**FSD Connects with the Construction Industry
to Speed up Building Plan Processing and Acceptance Inspection of FSI**

**FSD connects with the
Construction Industry to speed up
Building Plan Processing and
Acceptance Inspection of FSI**

24.11.2017

Example 2

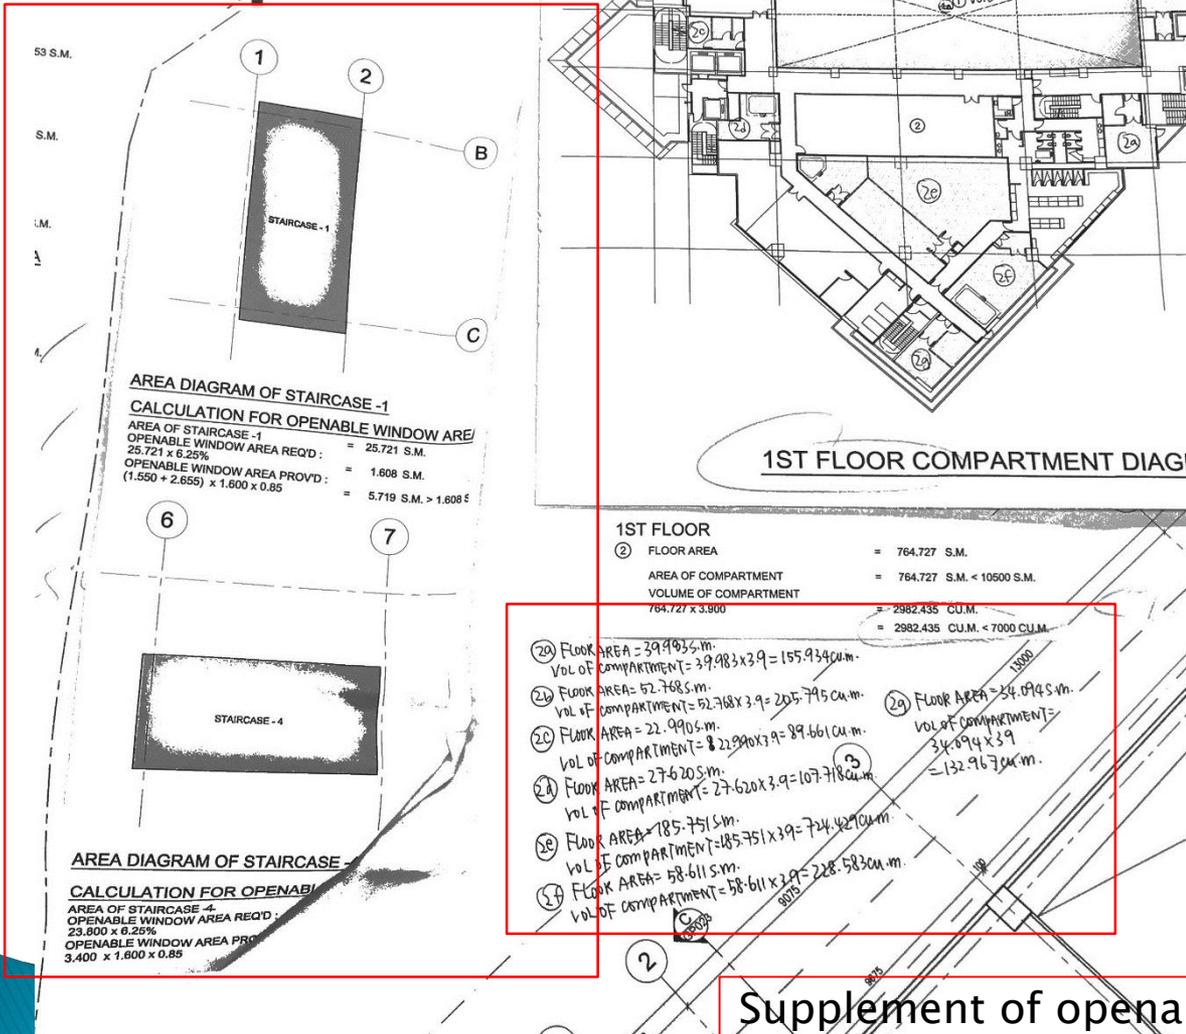
Original Version (FS notes with multi-irregularities spotted by plan processing officer)

1) FIRE HYDRANT & HOSE REEL SYSTEM *CL 2/2017??*

A) 1 NO. EACH OF 2 CU/M F.S. WATER TANK TO BE PROVIDED TO SERVE THE FIRE HYDRANT / HOSE REEL SYSTEM FOR EACH OF THE HOUSE. *2m³ FS Tank*

B) NO FIRE HYDRANT WILL BE PROVIDED. *DA*

2) MANUAL FIRE ALARM *DA*

A MANUALLY OPERATED FIRE ALARM SYSTEM WILL BE PROVIDED FOR B/F ONLY AND WILL BE INCORPORATED IN THE FHIR SYSTEM IN ACCORDANCE WITH BS 5839-1:2002 + AS:2006 FSD CL 1/2006. ONE ACTIVATING POINT AND ONE AUDIO WARNING DEVICE TO BE LOCATED AT EACH HOSE REEL POINT. THIS ACTIVATING POINT SHALL INCLUDE FACILITIES FOR FIRE PUMP START AND AUDIOVISUAL WARNING DEVICE INITIATION WITHIN THE PREMISES. *DA*

B) THE SPRINKLER SYSTEM IS CLASSIFIED AS ORDINARY HAZARD GROUP III. *GROUP III*

C) THE AUTOMATIC SPRINKLER SYSTEM WILL BE PROVIDED AND INSTALLED IN ACCORDANCE WITH LPC RULES INCORPORATING BS EN 12845:2003 AND FSD CIRCULAR LETTER NO. 3/2005 AND 3/2012. *70m³*

E) A DIRECT LINK CONNECTION TO BE PROVIDED TO THE FIRE SERVICE'S COMMUNICATION CENTRE. *DL*

G) SPRINKLER HEADS COVERING THE B/F SHALL OF FAST RESPONSE TYPE. *PRT*

Amended Version – AP's representative was allowed to make amendments by pasting a cover sheet at FSD's office.

A) 1 NO. EACH OF 9 CU M. F.S. WATER TANK TO BE PROVIDED TO SERVE THE FIRE HYDRANT & HOSE REEL SYSTEM FOR EACH OF THE HOUSE.

~~B) NO FIRE HYDRANT WILL BE PROVIDED AS INDICATED ON PLANS.~~

A) AUTOMATIC SPRINKLER SYSTEM WILL BE PROVIDED TO COVER ALL PARTS AT LGF ONLY FOR HOUSE 1 AND 2 AND ALL FLOORS FOR HOUSE 3 EXCEPT E & M PLANT ROOMS, PIPE DUCTS, ELECTRICAL DUCTS AND ST LOBBY.

B) THE SPRINKLER SYSTEM IS CLASSIFIED AS ORDINARY HAZARD GROUP II FOR LGF HOUSE 1 AND 2 AND ORDINARY HAZARD GROUP I FOR 1F & 2F FOR HOUSE 3.

D) ~~1 NO. EACH OF 20 CU M. SPRINKLER TANK TO BE PROVIDED FOR EACH OF THE HOUSES~~ AS INDICATED ON PLANS. THE WATER SUPPLY IS SINGLE END FEED. ^{102m² - H13 LGF} ~~1 NO. EACH OF 105 CU M. SPRINKLER TANK TO BE PROVIDED FOR EACH HOUSE~~

Fire Service Notes not tally with the building use

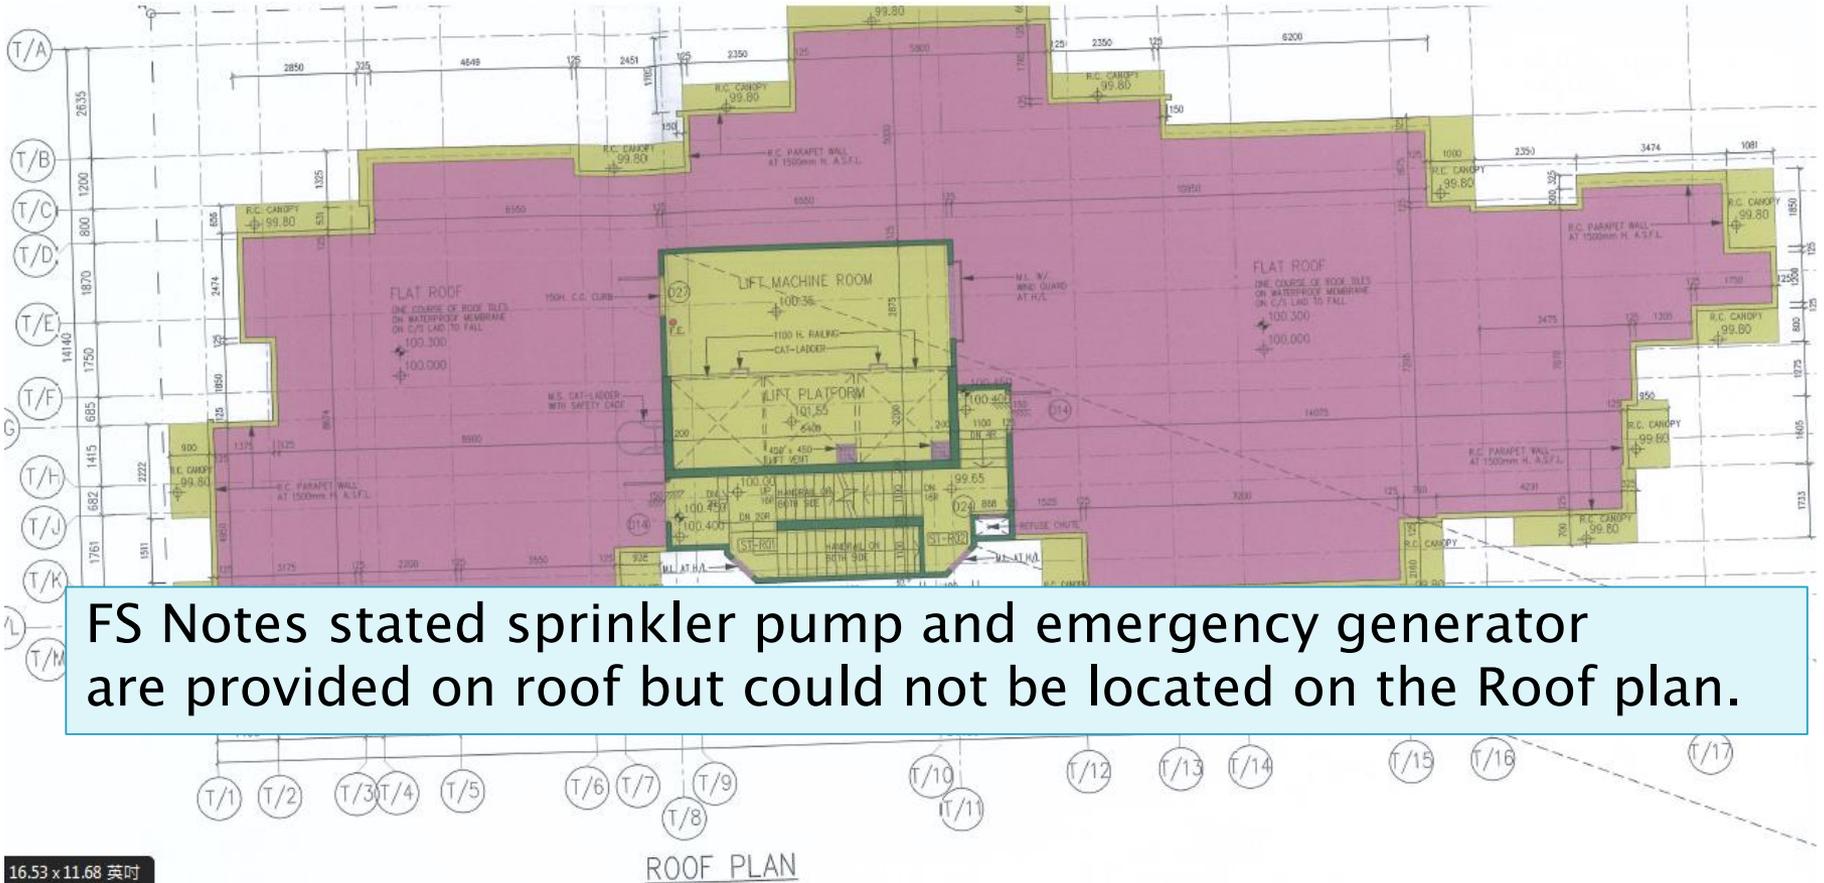
OH1

54m³
for Inlet

Refuge areas stated on FS notes but no Refuge Floor on plan!!!

Re-submission required

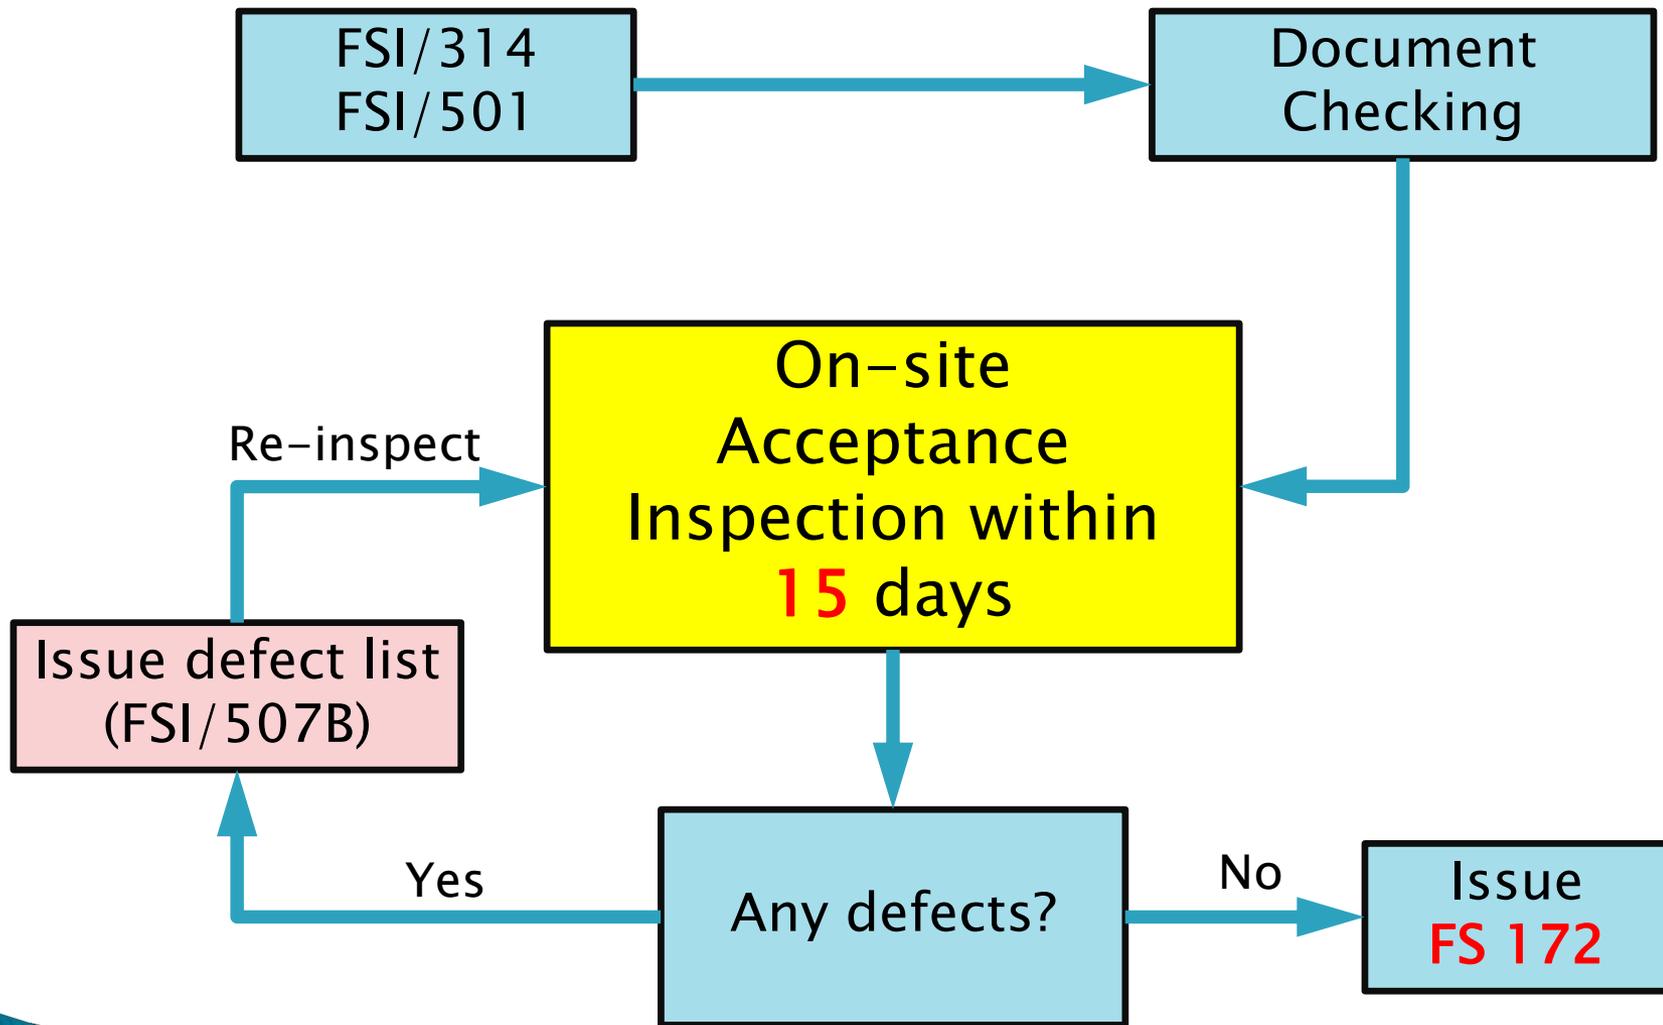
The building plans in respect of the above project have been examined and Fire Services Certificate (F.S. 161) under Section 16(1)(b) of the Buildings Ordinance cannot be issued due to non-compliance with the following requirements in accordance with the current *Code of Practice for Minimum Fire Service Installations and Equipment (April 2012 Version)* (the Code):-

- (i) Fire service installations or equipment shall be provided in accordance with paragraphs 4.15 and 4.26 of the Code;
- (ii) The designed Hazard Group of the sprinkler system shall be stated clearly in FS Notes;
- (iii) The sprinkler tank size shall be provided in accordance with the LPC Rules incorporating BS EN 12845:2003 and the FSD Circular Letter 3/2006 for the designed Hazard Group;
- (iv) The sprinkler inlets and sprinkler valve shall be indicated on plans;
- (v) The FS tank shall be indicated on plans;
- (vi) Intermediate booster pumps shall be provided for building where the height between the topmost hydrant and the lowest FS inlet is in excess of 60m;

A series of uncorrectable irregularities, plan rejected.

- (ix) The set of FS inlet near Hung To Road shall be relocated to a prominent position on the exterior of the building;

Please also be reminded that EVA provision shall comply with the *Code of Practice for Fire Safety in Buildings 2011* and APP-136 – Building (Planning) Regulation 41D Emergency Vehicular Access.

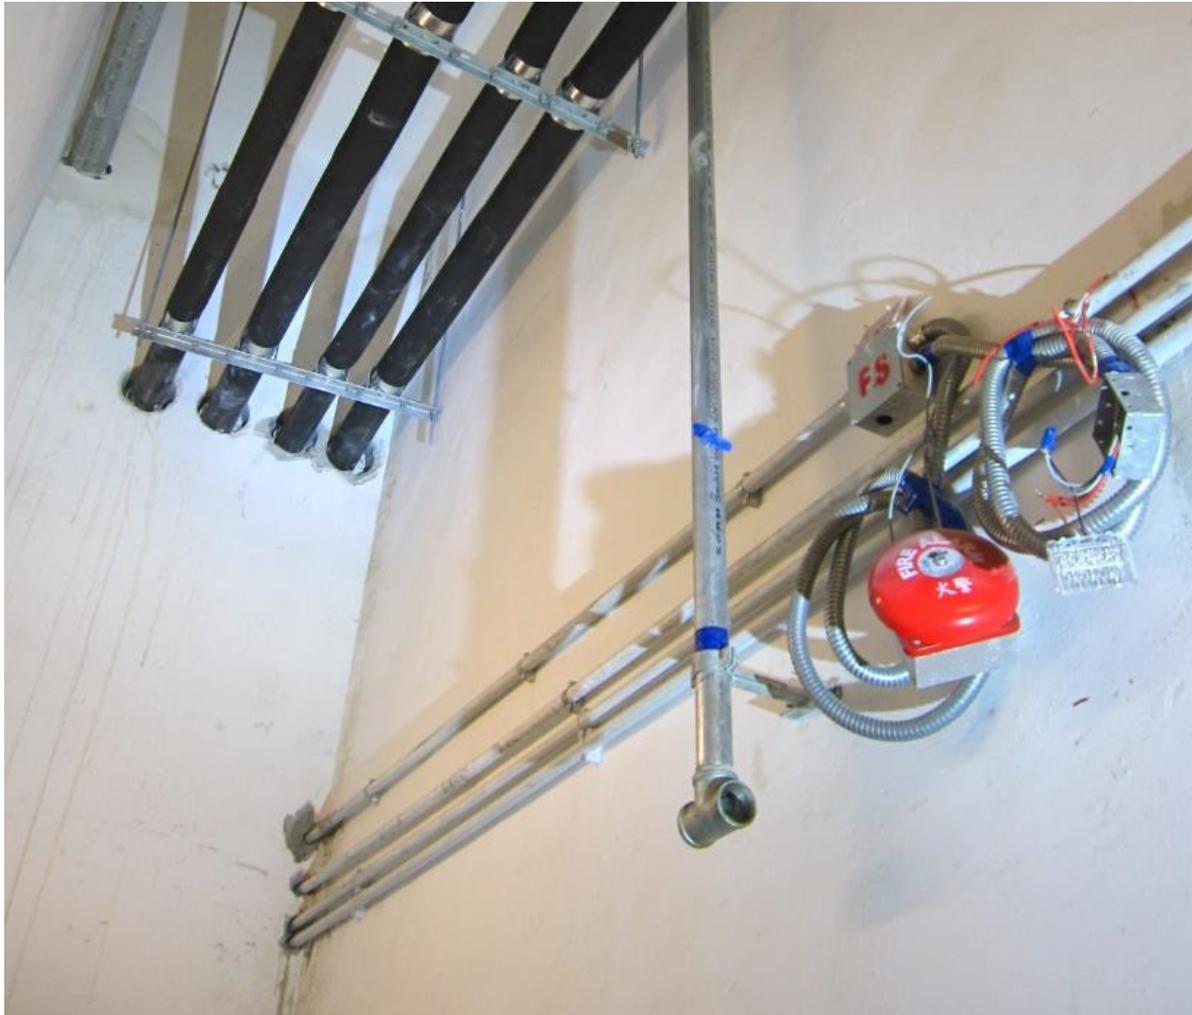
- ▶ Incomplete building works
 - e.g. missing of fire doors for staircase pressurization system
- ▶ Temporary structures
 - e.g. blockage of sprinkler heads by working platform

x Incomplete pipework of sprinkler system

x Incomplete pipework of sprinkler system

x Blockage of sprinkler head

x Incomplete installation of concealed type sprinkler head
